Subject: RE: Appeal application

I will hold off on reinspection of 673 Charles.

673 Charles Ave.photos 8-20-25

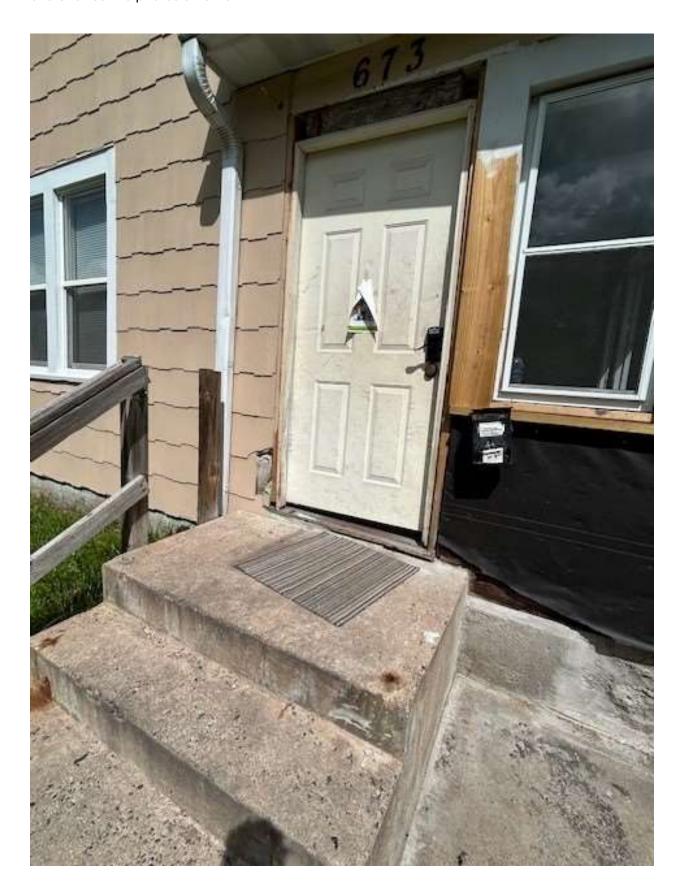
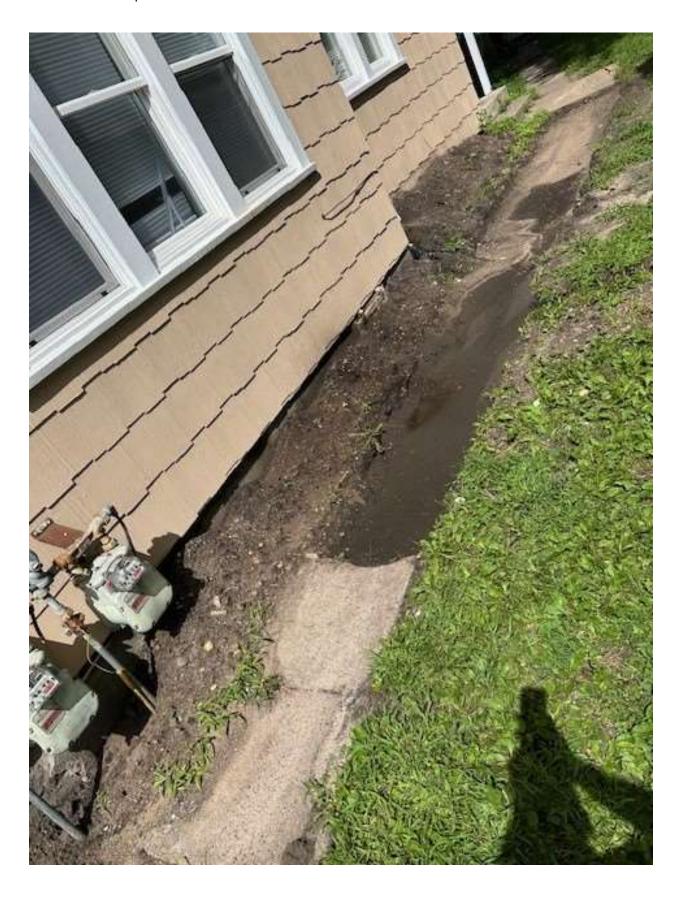
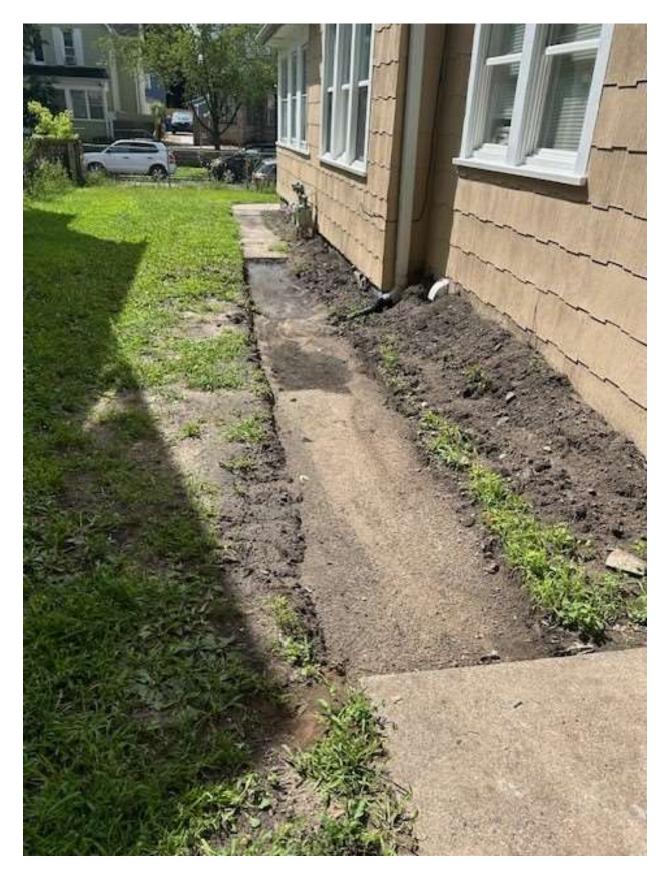
- 1-3 are the front door exterior and show how the door is not framed to code nor impervious to the elements or critters. It also shows the window framing with lack of waterproofing and missing siding below it.

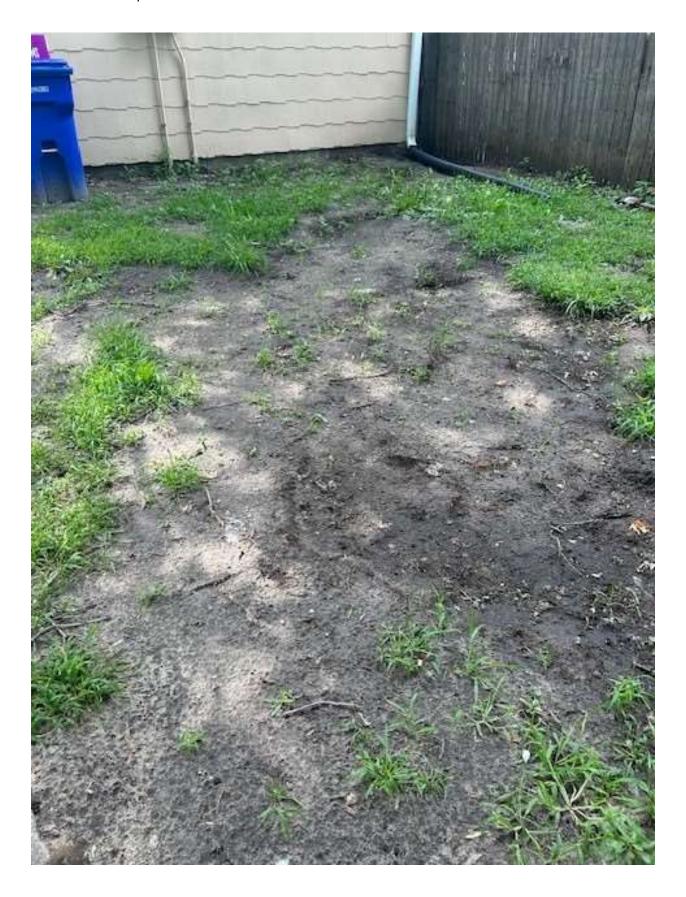
- 4-5 show a large vacant space where a sidewalk once was and the erosion that is happening in its absence, a slipping, tripping, and falling hazards.

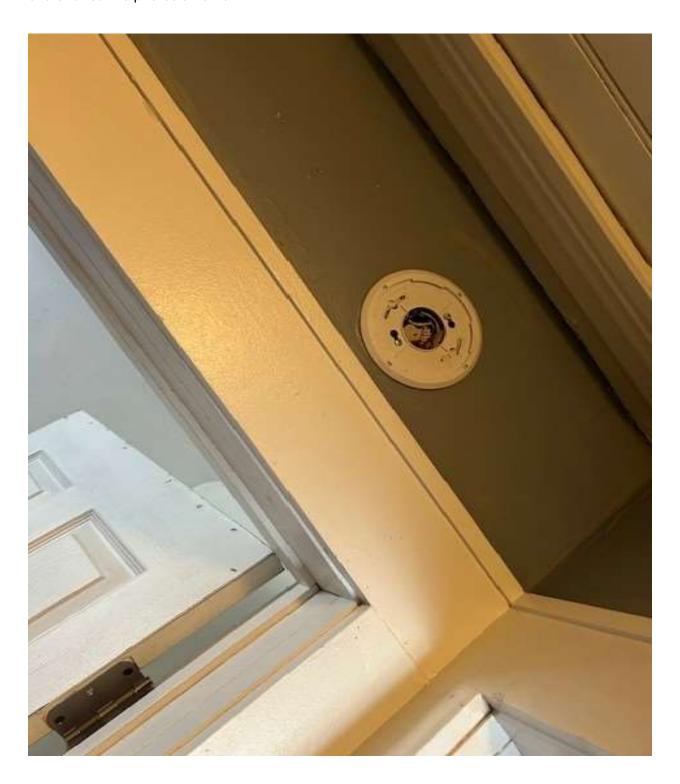
- 8 shows the hole in the wall of the lower units bathroom, in the rear stairwell.
